## **Nevada Division of Environmental Protection BART Determination Review of NV Energy's Tracy Generating Station Units 1, 2 and 3**

A BART analysis was completed by CH2M HILL at the request of NVEnergy (NVE) for units 1, 2 and 3 at the Tracy Generating Station (Tracy) dated October 3, 2008. Tracy consists of three BART eligible units with a generating capacity of 251 megawatts (MW), of which unit 1 is a 55 MW, unit 2 is 83 MW and unit 3 is 113 MW. The Title V permit allows burning pipeline quality natural gas (PNG) or blended residual (No. 2 and No. 6 and non-PCB mineral oil) fuel oil. In completing the BART analysis, technology alternatives were investigated and potential reductions in NO<sub>x</sub>, SO<sub>2</sub> and PM<sub>10</sub> emissions rates were identified by NVE. NVE's BART analysis is summarized below, organized according to the five step analysis contained in Appendix Y of 40 CFR 51 Appendix Y, followed by NDEP's review and BART determination.

**FIGURE 1**

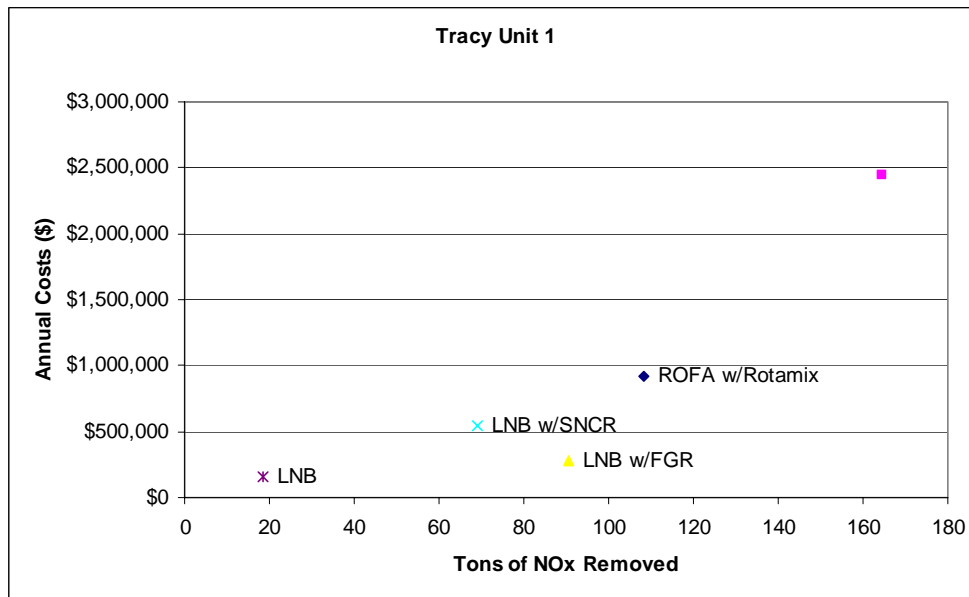
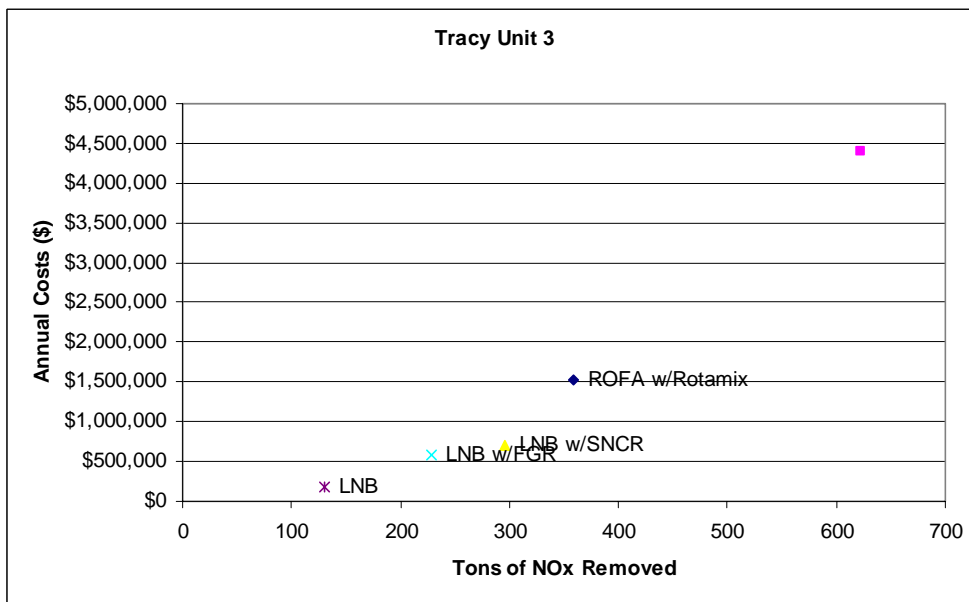
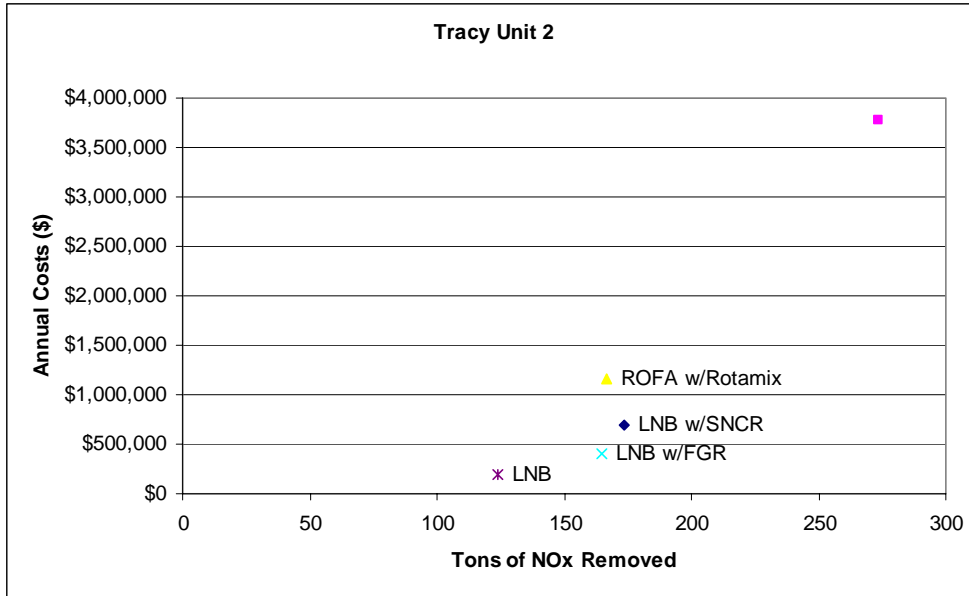
NDEP specifically reviewed the cost per ton of NO<sub>x</sub> removed for each unit at Tracy and determined that installation of LNB with FGR for units 1 and 2, as well as LNB with SNCR for unit 3, meets the BART criteria. Associated first year costs range from \$2,383 to \$3,050/ton of NO<sub>x</sub> removed. These values are considered cost effective. The cost data from the tables above are presented graphically for each unit in Figure 1. NDEP also concluded based on a review of the economic analysis that the \$/ton of NO<sub>x</sub> removed for units 1 and 2 increased significantly for LNB with SNCR, ROFA with Rotamix, and SCR with only slight improvements in visibility. Similarly, the \$/ton of NO<sub>x</sub> removed for units 3 increased significantly for ROFA with Rotamix and SCR with only slight improvements in visibility.

NDEP concludes that for NO<sub>x</sub> the installation of LNB with FGR with an emission limit of 0.15 lb/MMBtu for unit 1 and 0.12 lb/MMBtu for unit 2, as well as LNB with SNCR with an emission limit of 0.19lb/MMBtu for unit 3, on a 12-month rolling average, is BART.
